Urgent: Medical Device Correction

Update to Model 8870 Software Application Card used in the 8840 N'Vision® Clinician Programmer and SynchroMed® II Infusion System Labeling for Priming Bolus

November 2016

New tubing volume value of **0.140 mL**, replaces previous value of 0.199 mL

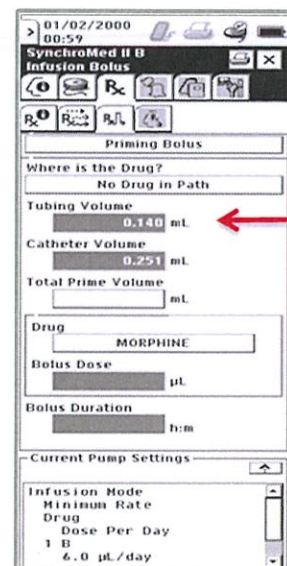
The software update will change the value displayed on the 8840 programmer for the SynchroMed II pump tubing volume from 0.199 mL to **0.140 mL** (see picture). The tubing volume is used to calculate the total volume of a full system priming bolus. This volume change does not alter the procedural steps or the other calculations required to program a priming bolus.
